Re: Consultation on an Application

Planning Application Ref: PL/25/1662

Proposal: Application for Approval of Details Reserved by Conditions 5- (Hard & soft landscaping) of application PL/24/0487

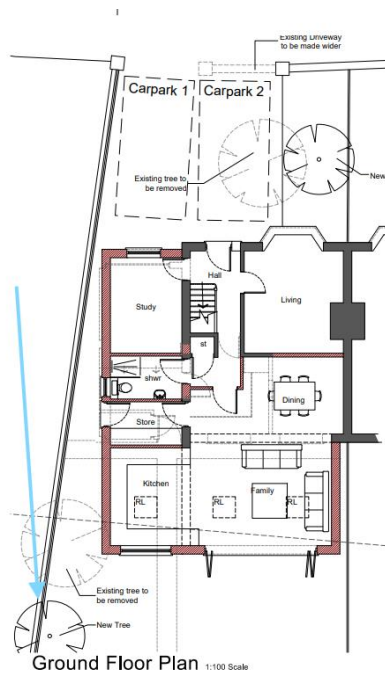
I note that the previous landscape document for PL/25/0822 (Landscaping and Kerb Details drawing, January 2025, BA 0275 04), has been resubmitted yet has not taken into consideration the suggested amendments I included in my previous comments. They therefore still stand and are as follows:

Watering: *The watering specification should be extended to include the amount of water; that being 20-25 litres weekly given the stock size proposed*
Additional watering during dry conditions should also be considered.

Planting Notes: *planting will take place in the 1st planting season following the construction, stating the planting will take place between October-March. Condition 5 states 'Planting shall be carried out in accordance with the approved details in the first planting (Nov-March) following the occupation of the building(s) or in accordance with a timetable agreed in writing with the Local Planning Authority.'* – The start of the planting season needs to be amended to begin in November, rather than October

This plan also needs to specify the following as part of the requirements of the condition (also mentioned in my comments for previous application):

If any of the trees, within a period of 5 years from the date of planting, die, are removed or become seriously damaged or diseased they shall be replaced in the next planting season with others of similar size and species, to be agreed in writing by the Local Planning Authority

This has now been amended with additional watering included which meets with the requirement of the Condition..

This has now been amended and meets with the requirements of the Condition.

This has now been included and meets with the requirements of the Condition.

Rear tree location in revised Proposed Rear Tree Plan (in close proximity to the brick shed)

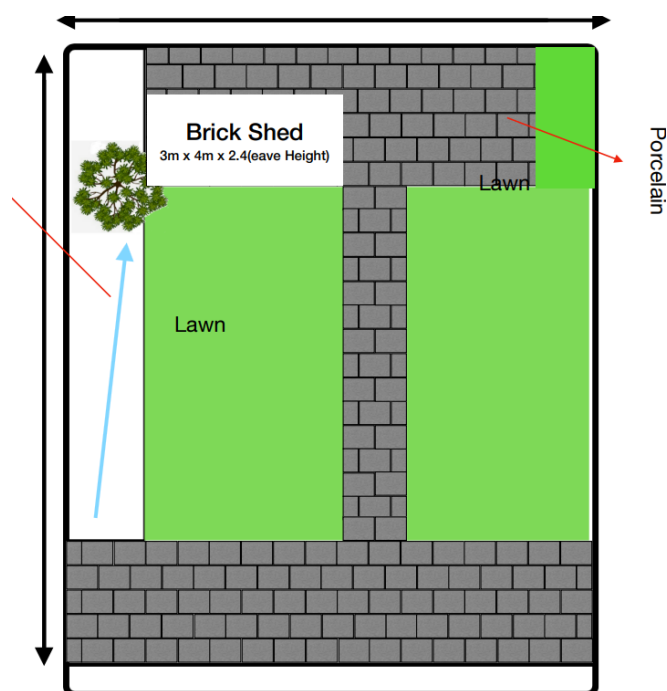
With reference to the Proposed Rear Tree plan, I note the only the lawn area and tree are plotted. I am unclear on the surfacing proposed in the white areas below. Hard surfacing also needs to be demonstrated as per the requirements of the condition. I also note the tree appears to be planted within the hard surfacing or containerised bed (unclear due to lack of labels – see slightly shaded area). So, clarity is required on this as I question why it is not being planted within the lawn area. I also note this tree is also an Apple (Malus) which is the same genus as that on the frontage and thereby offers no diversity other than the difference in cultivar. I encourage a different species is used here to improve diversity.

will support the tree reaching its ultimate size rather than confining it to a limited volume of soil. The species in the rear garden has also been reconsidered which is positive as this offers more diversity. I do have concerns that the tree is now in close proximity to the brick shed and this is likely to lead to future conflict between the tree and the shed in the future, which may make tree retention undesirable. The approved plan shows the tree in a different location than that in the revised Proposed Rear Tree Plan. I encourage that the applicant reconsiders its location to represent that of the approved plan and to avoid conflict in the future with the shed which will aid in long-term retention of the tree.

Clarity has been provided on the hard surfacing which meets the requirements of the Condition. The applicant has also stated via email of 12th January 2026, that the tree will be planted directly into the ground, rather than in a planting bed, which is positive. This
